ADDENDUM No. 1 – March 25, 2026

DATE: 03/23/26
DRAWING NUMBER:
ADD-01
A-001

PROJECT TITLE:
Tufts Vet Tech Clinic Renovation
Worcester Technical High School
1 Officer Manny Familia Way, Worcester, MA 01605

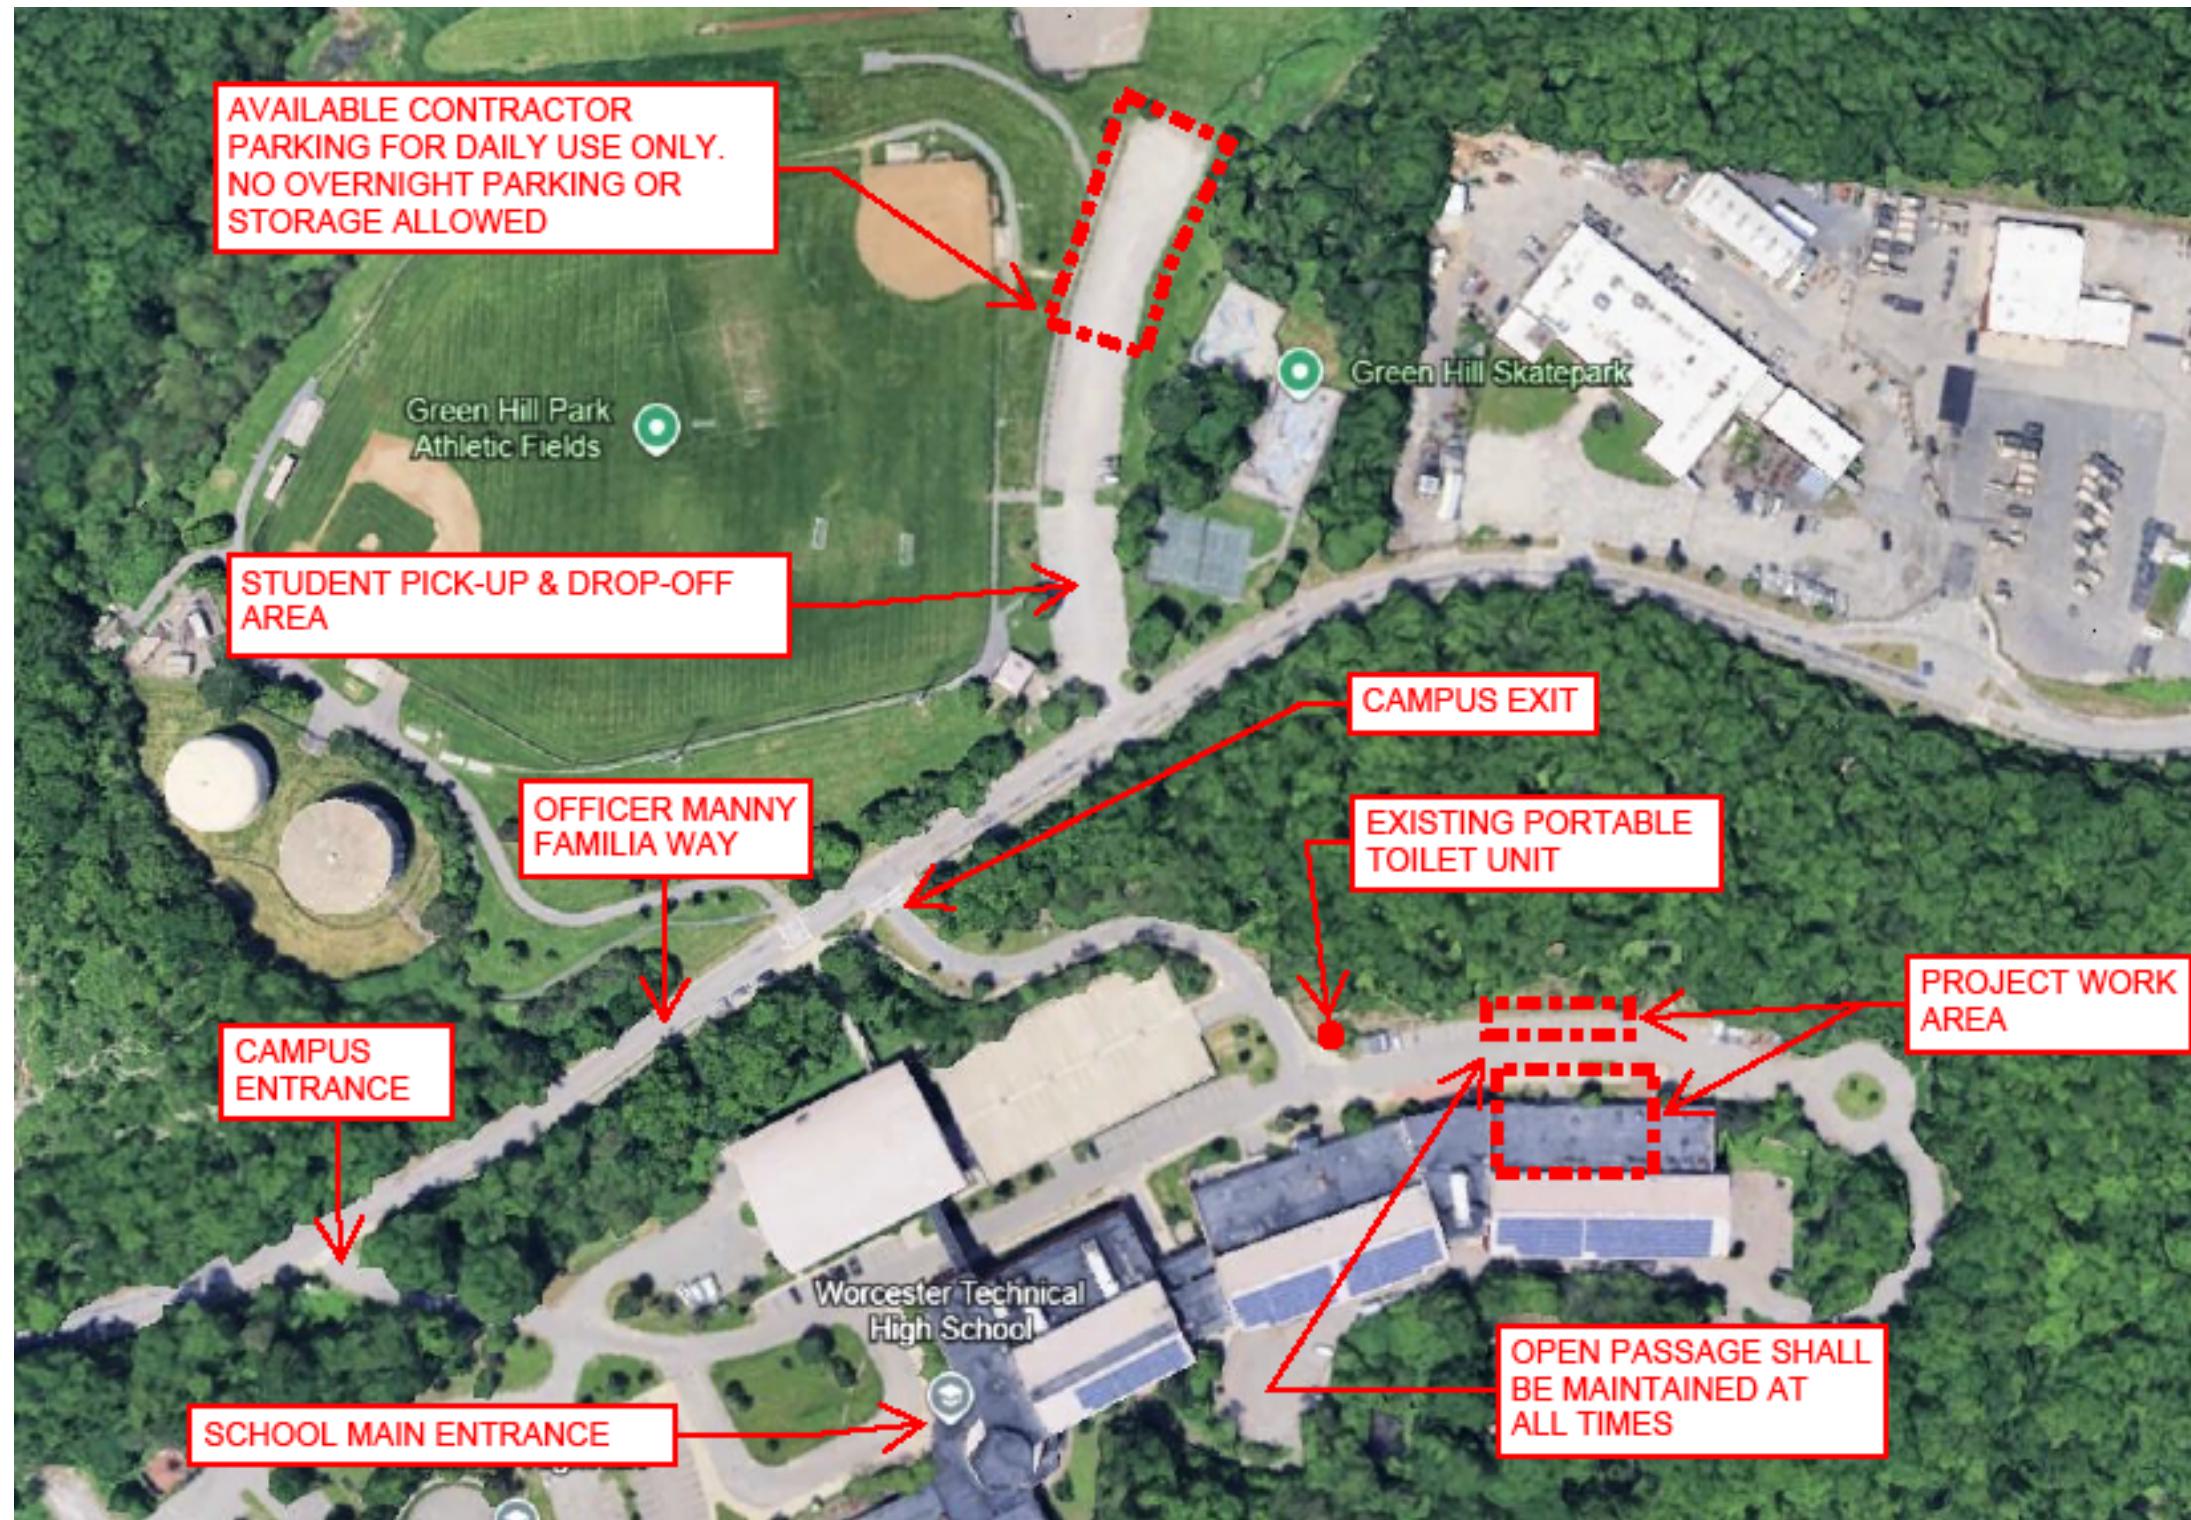
Delete: 6/AD3.3 Partial Campus Plan

Insert: 6/AD3.3 Partial Campus Plan, revised as shown in sketch ADD-1/A-001, included in this addendum.

1 Partial Third Floor Plan - Section D (Partial)
 A3.1 SCALE: 1/8" = 1'-0"

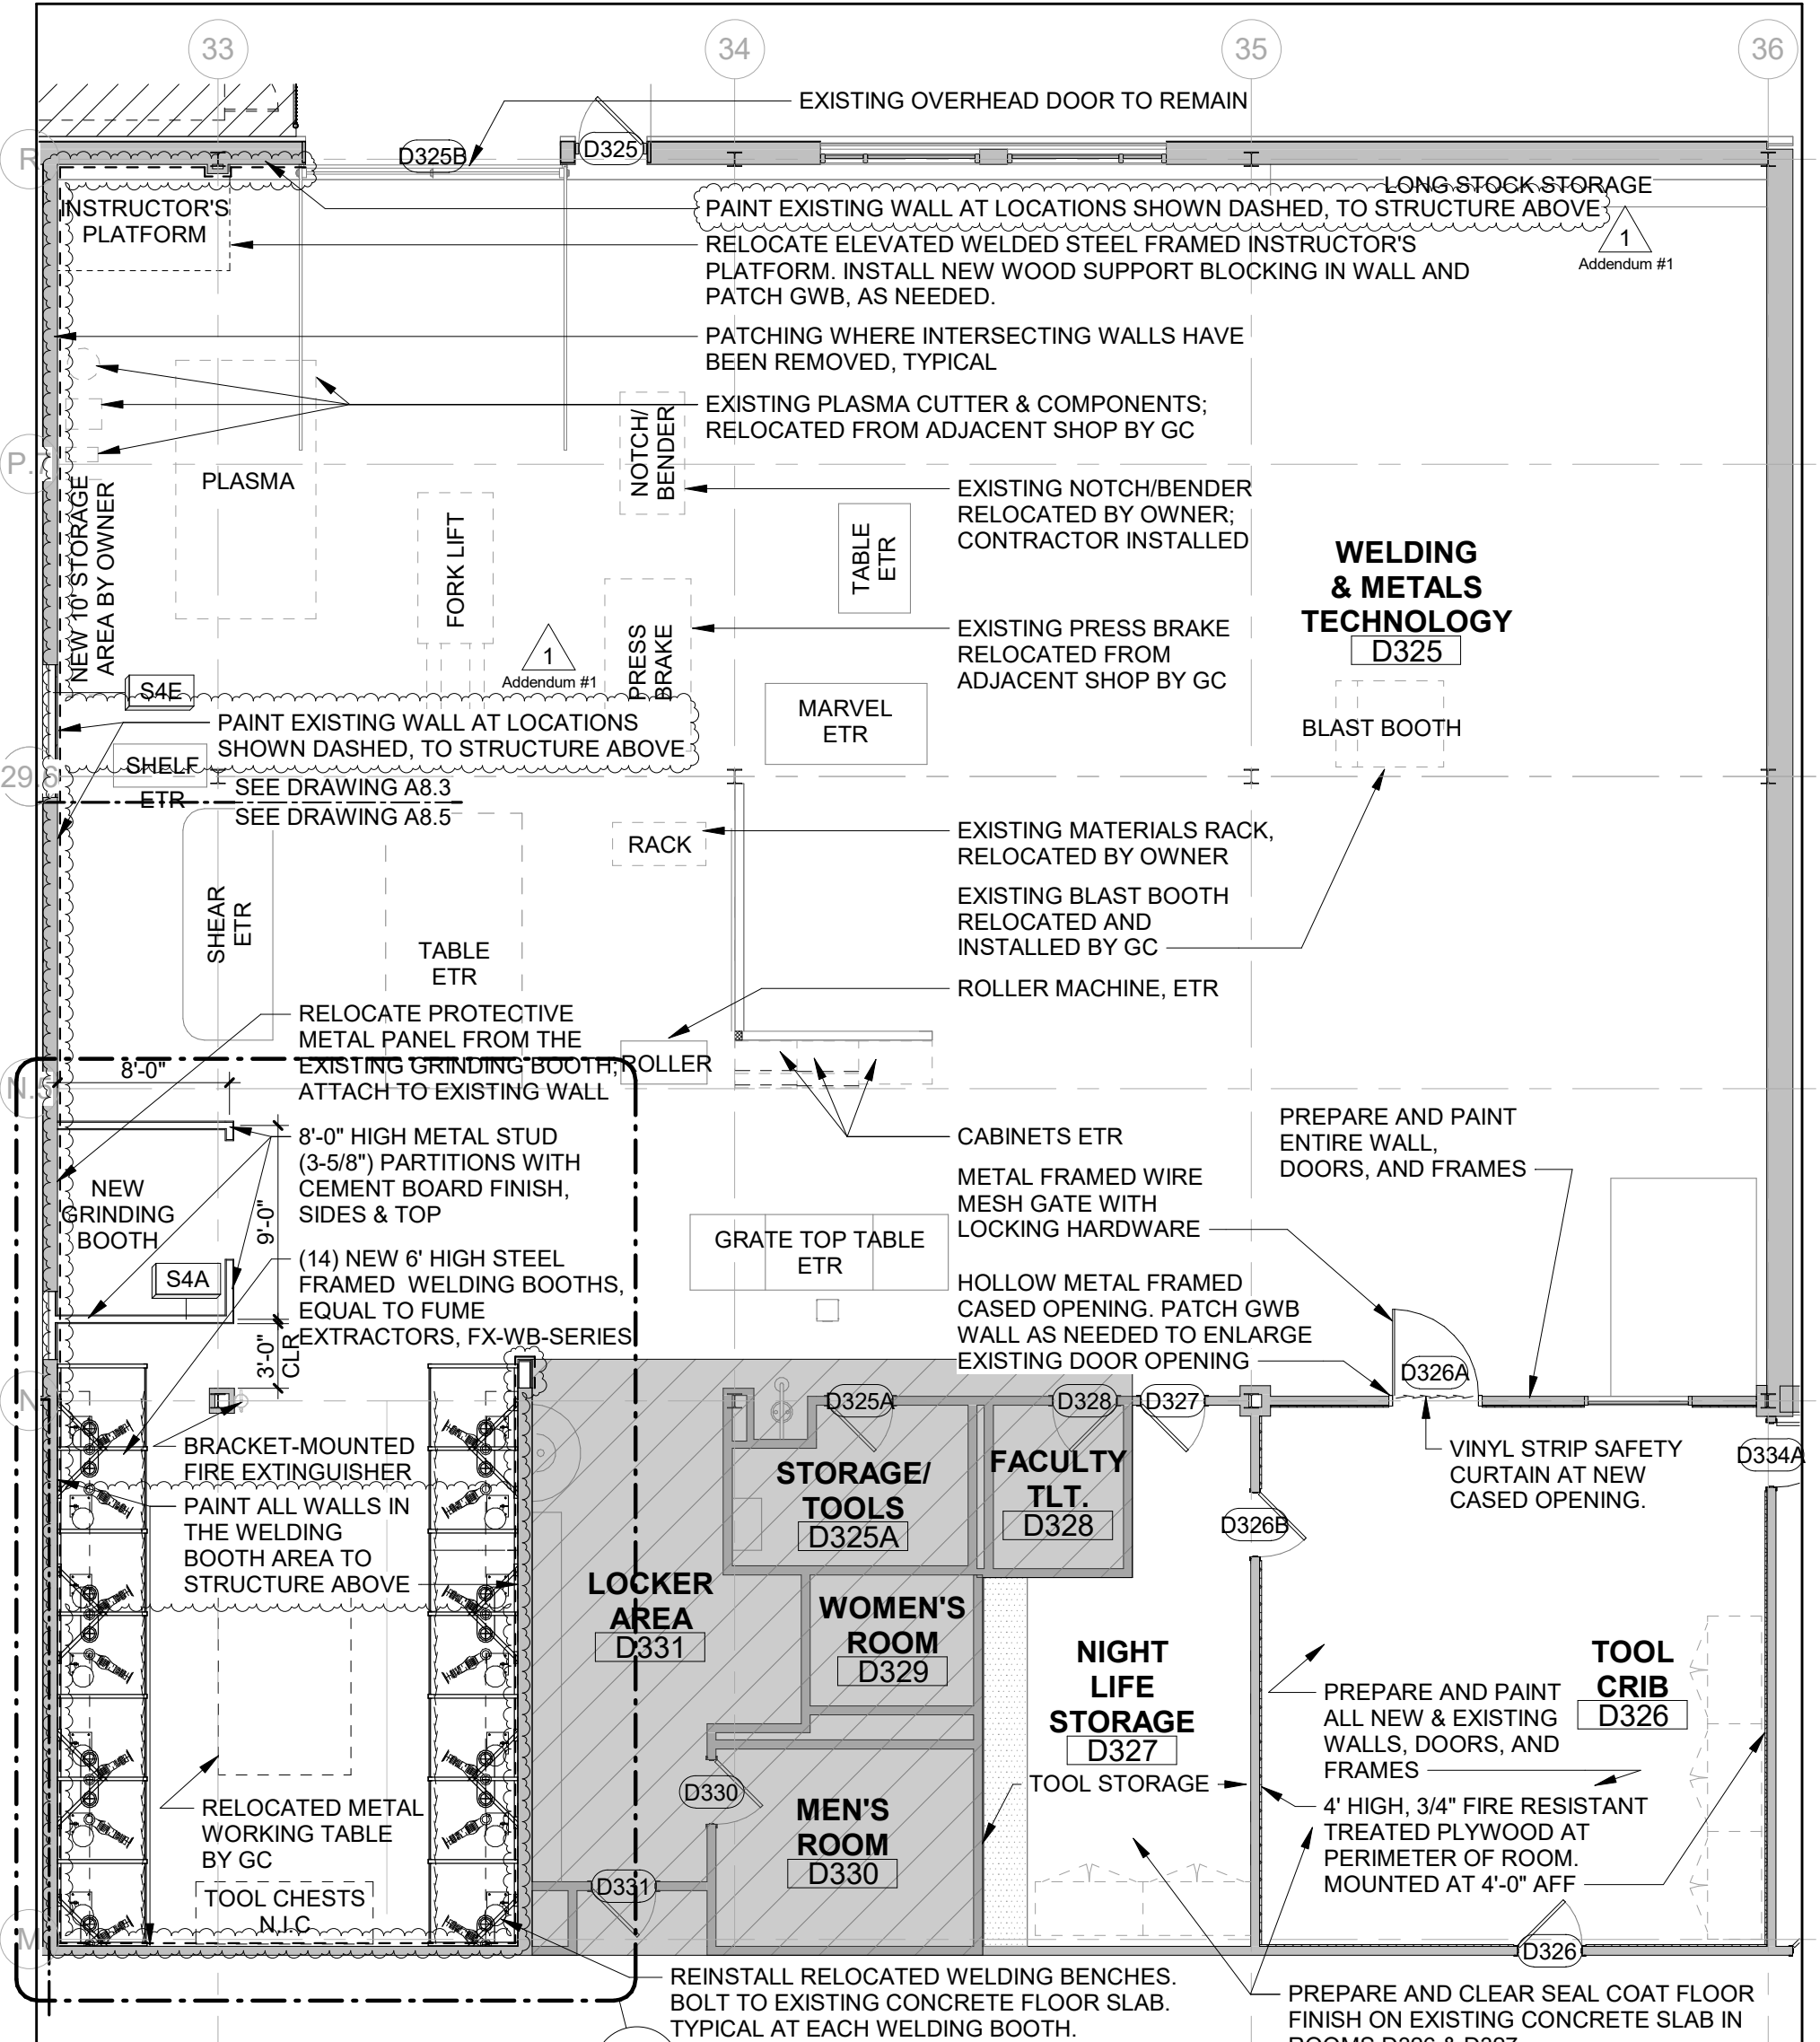
Insert: Painting notes in Welding & Metals Technology D325 as shown in sketch ADD-01/A-002.

Insert: Note 5. The final location of the relocated metals technology equipment in Welding & Metals Technology D325 shall be determined in the field. The GC shall coordinate all new electrical connections in relation to the equipment location.

| QUESTION | RESPONSE |
|---|---|
| The extent of wall painting in D325 is unclear. The Floor Plan on A3.1 has notes calling for all walls except the North to be painted in their entirety but the Room Finish Plan on A11.1 shows painting is much more limited. Which drawing is correct? | See Part 3, note 2 of this addendum. |

ADDENDUM 1 – DRAWING 9.1 – LAB D317A CASEWORK

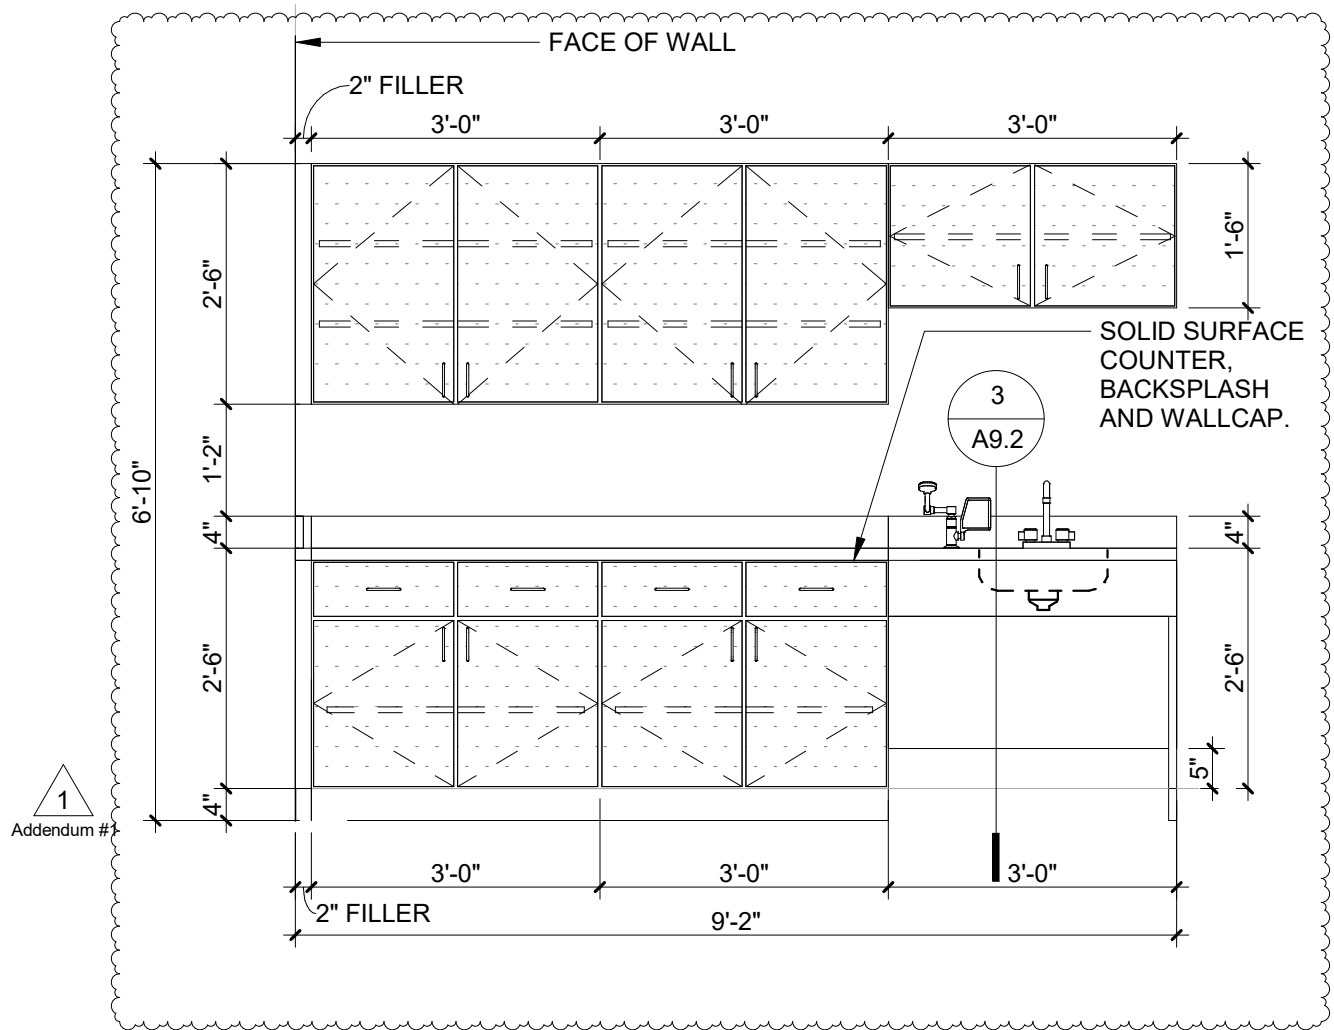
Insert: CW13 LAB D317A CASEWORK, as shown in sketch ADD01/A-004 included with this addendum.

| QUESTION | RESPONSE |
|---|--|
| In Lab D317A on drawing A9.6; CW 13 is called out but does not exist on A9.1, should we assume Lab 317A casework is CW5? (+CW 12)? | See Part 3, note 4 of this addendum |

ADD-01
A-005

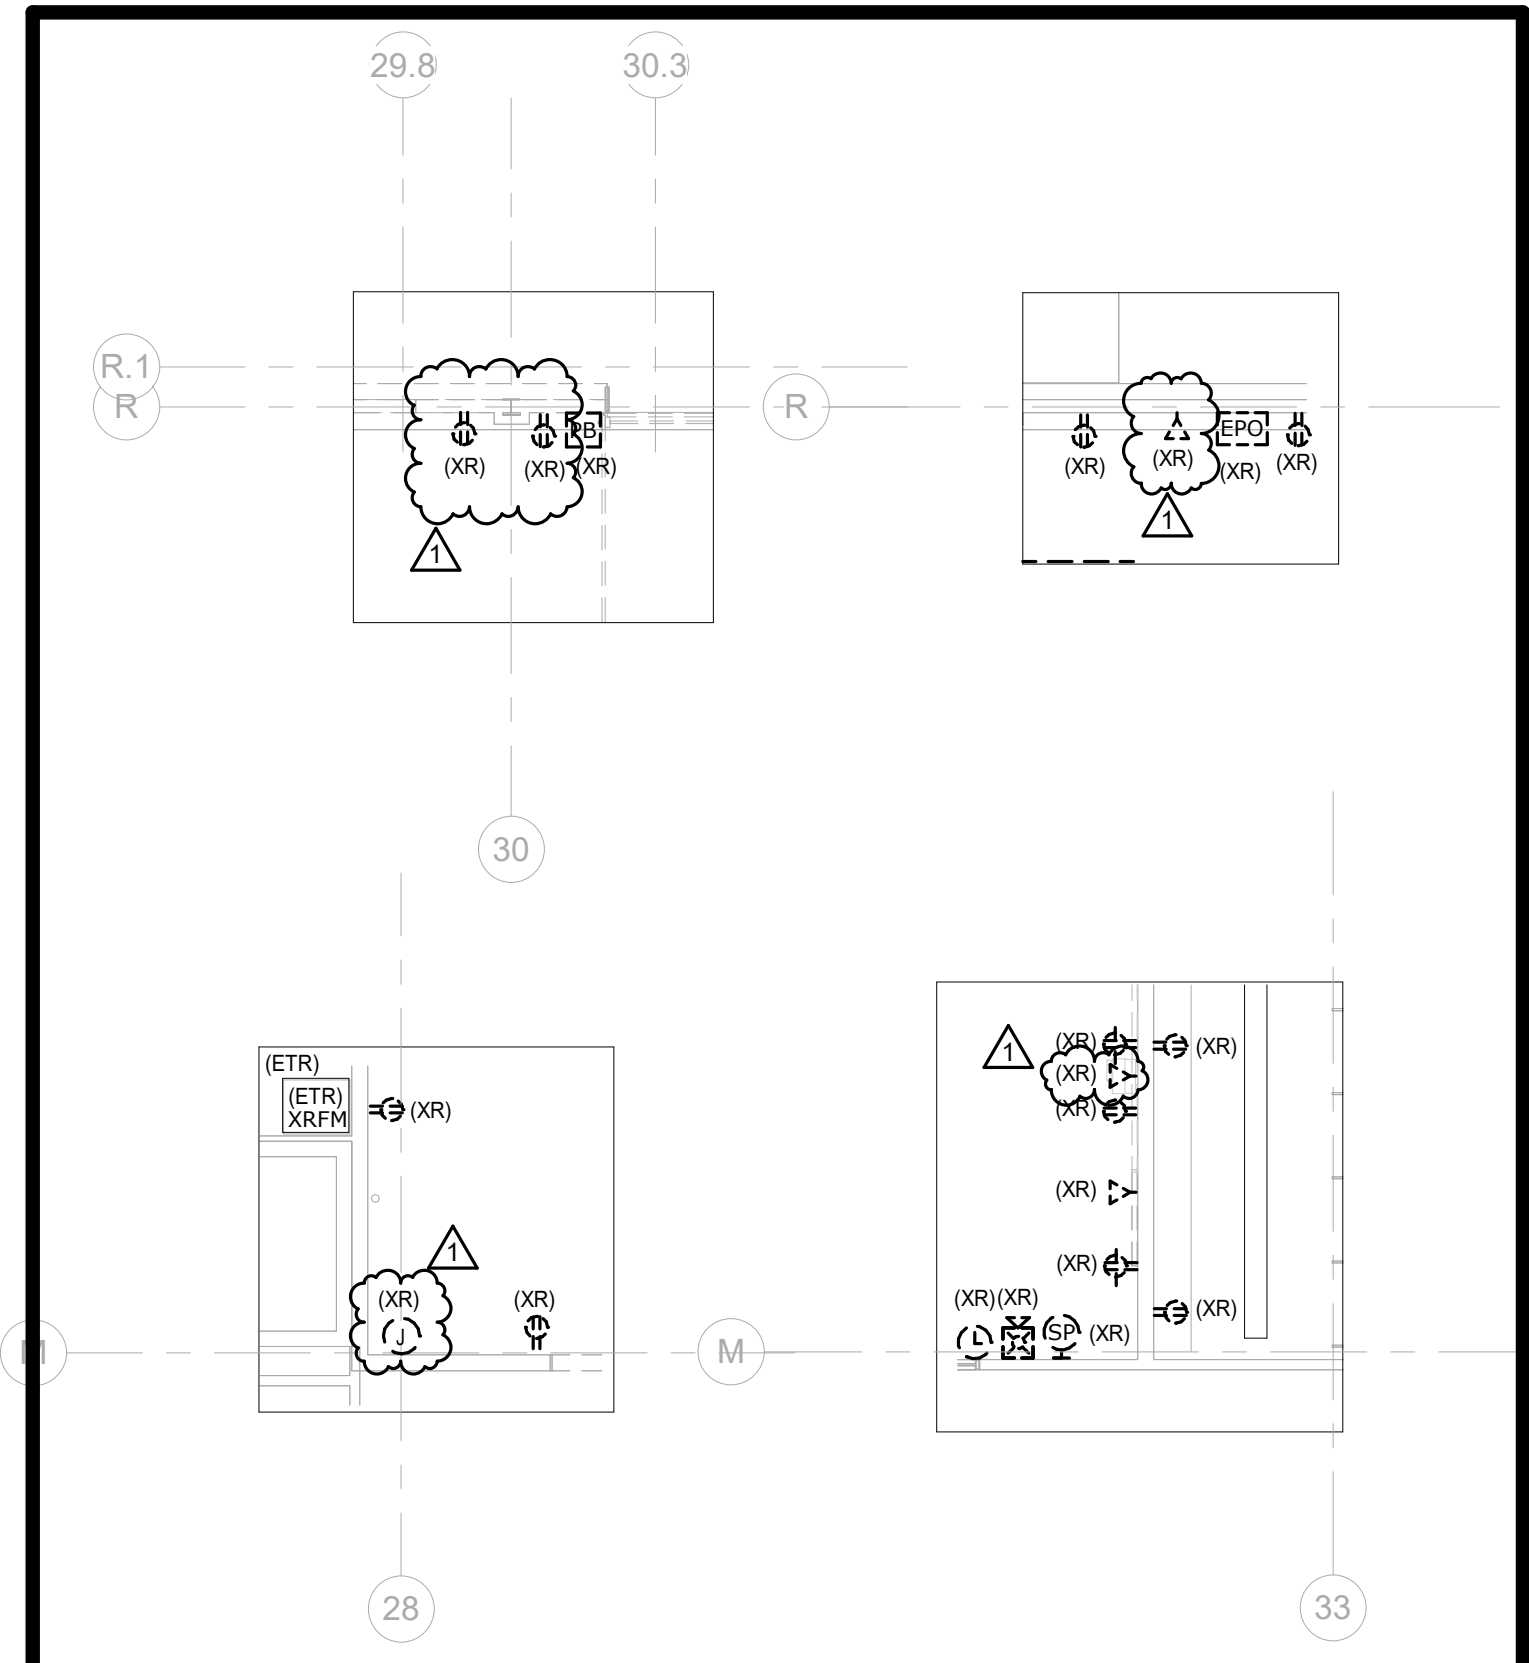
Add: Notes 7, 8, and 9 as shown in sketch ADD-01/A-005 included with this addendum.
